CONTRACT REPORT

Road Safety Audit - Cambridge and Moorebank Avenues, Moorebank - Construction Traffic Accesses

Project No: PRS17114

Figure 3.1: Road safety audit location of issues

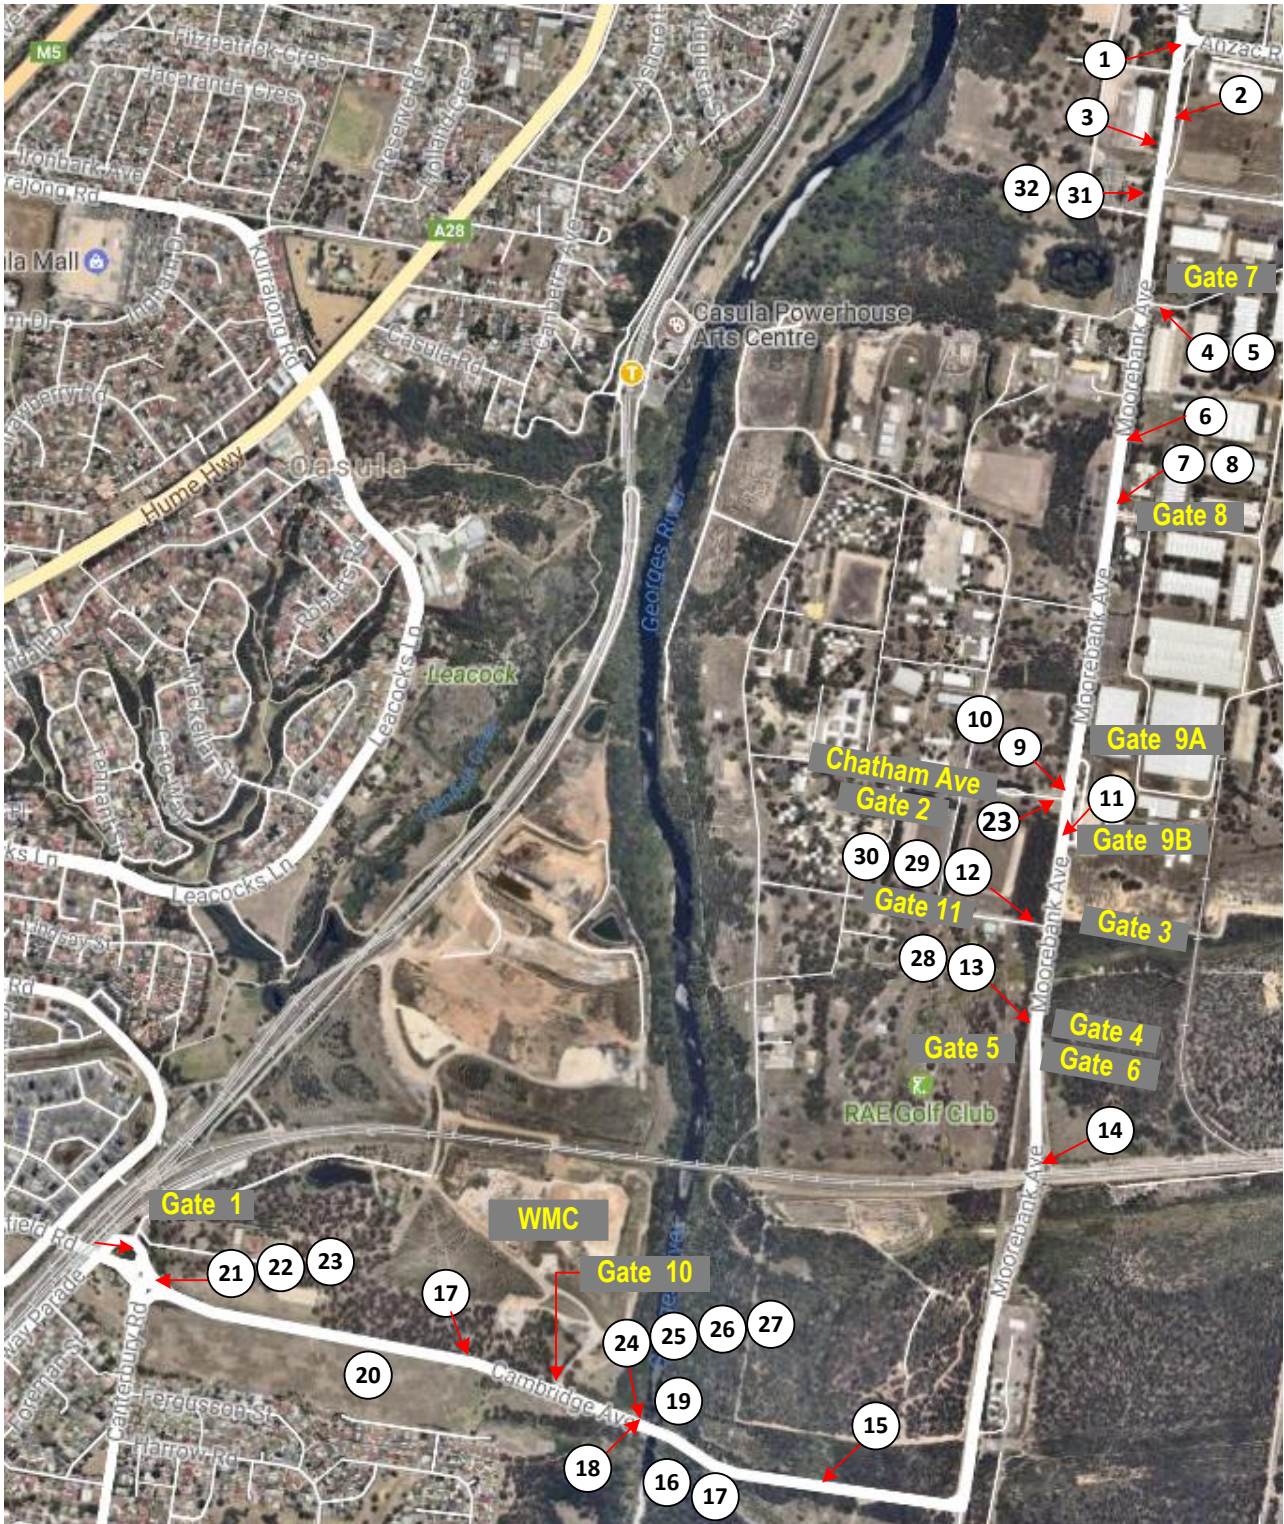
A detailed tabulation of all the road safety audit findings along Moorebank and Cambridge Avenues is presented in Table 3.2, with the location of each issue shown in Figure 3.1.

Photo
Id
P

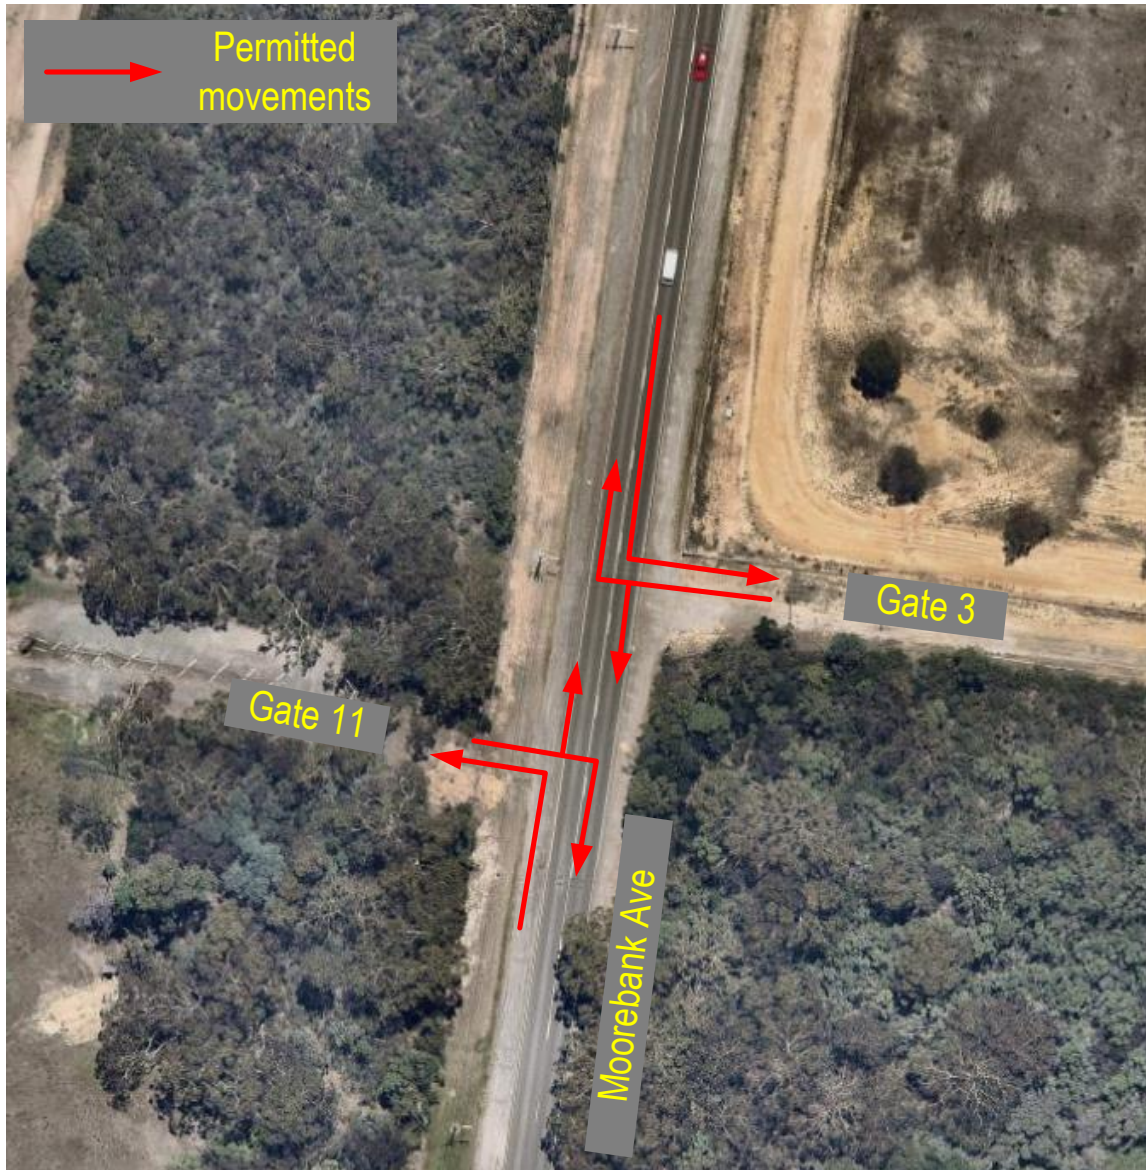
Issue no.	Site photo	Road safety issue	Risk rating	Suggested actions (Risk mitigation options)	Residual risk	Primary responsibility	Client response/action
11	O	<p>Gate 9A, 9B: Heavy vehicles turning left out of Gate 9B will have a wheel path on the unsealed shoulder which also has a drop from the sealed carriageway. This manoeuvre will cause deterioration to the unsealed shoulder, the edge of seal and create unstable driving conditions for vehicles, particularly in wet conditions.</p>	Medium	<p>Upgrade shoulder area to provide sufficient turning path onto Moorebank Ave, and repair the edge drop at the sealed pavement shoulder interface.</p>	Low	Road asset manager/SIMTA	
12	P	<p>Gate 3 and 11: The traffic movements associated with the staggered T intersection (formed by proposed Gate 3 and Gate 11 with Moorebank Ave) may create traffic flow disruptions and the potential for rear end crashes on Moorebank Avenue.</p> <p><i>[Note: Advice from CPB Contractors is that right turn movements from Moorebank Ave into Gates 3 and 11 are not required for the proposed operations and therefore potential safety issues associated with these movements are not considered.]</i></p>	Medium	<p>Formalise the Gate 3 and Gate 11 intersections with Moorebank Ave by appropriately treating the road shoulder areas to provide for left turn movements (i.e. both from and into Moorebank Ave) for the largest regular vehicle using the location.</p> <p>Provide 'Truck Turning' warning signs (to AS1742 design) on the north and southbound approaches.</p>	Low	SIMTA

AH

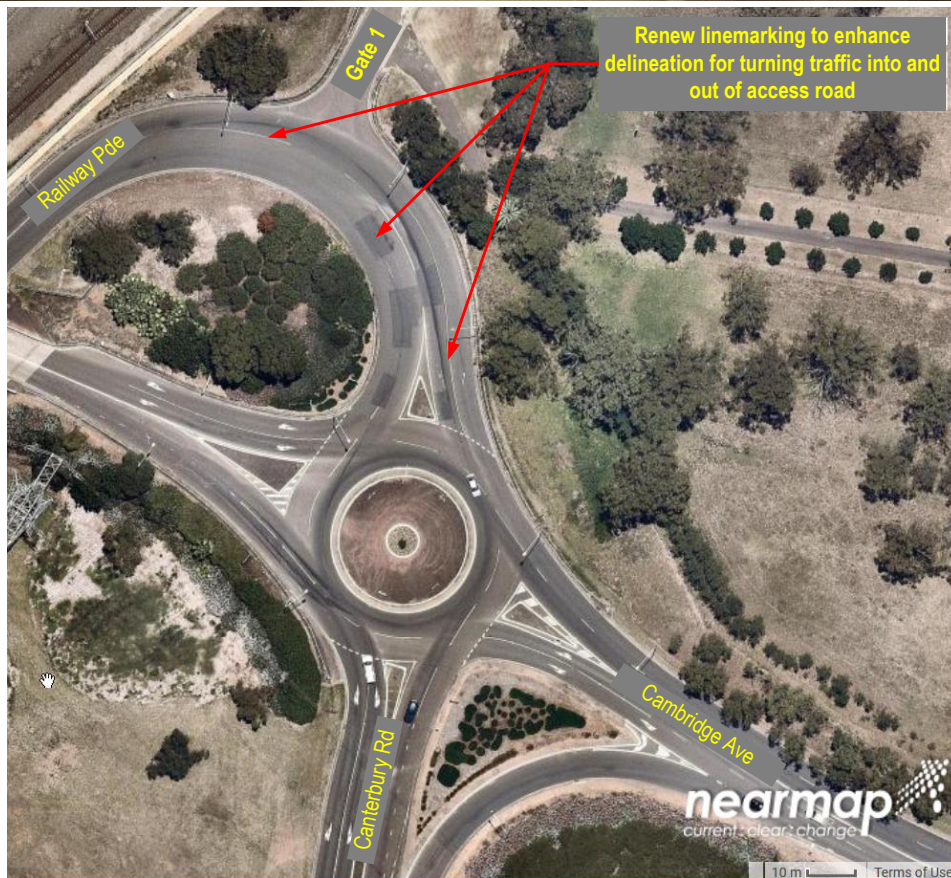
Issue no.	Site photo	Road safety issue	Risk rating	Suggested actions (Risk mitigation options)	Residual risk	Primary responsibility	Client response/action
22	AG, AH	Missing linemarking on roundabout exit creates confusion for drivers as to the correct lane and may cause sideswipe crashes. Truck sign is hidden behind vegetation and vehicles miss the warning of presence of trucks.	Medium	Repaint correct lane linemarking and trim vegetation to improve sign visibility.	Low	Road asset manager/SIMTA	
Cambridge Ave Eastbound							
23	AI, AJ, AK, AL, AM, AN	Gate 1: Damaged guardrail has reduced capacity to protect the structure behind from a heavy vehicle crash.	High	Repair damaged guardrail sections.	Low	Road asset manager	
24	AO, AP	Overgrown vegetation covering guardrail at the start of a merge reduces the effectiveness of the delineation of the barrier end and may cause a vehicle to crash into the hidden guardrail. Incorrect sign used for warning of narrow bridge. Sign is located too far ahead of location and presents incorrect information of road ahead. The warning sign installed too far ahead are not effective in warning of hazard ahead.	Low	Remove vegetation to allow guardrail to be visible. Replace incorrect 'Road narrows' sign with (W4-1) 'Narrow bridge' sign and install in accordance with AS 1742.2.	Nil	Road asset manager
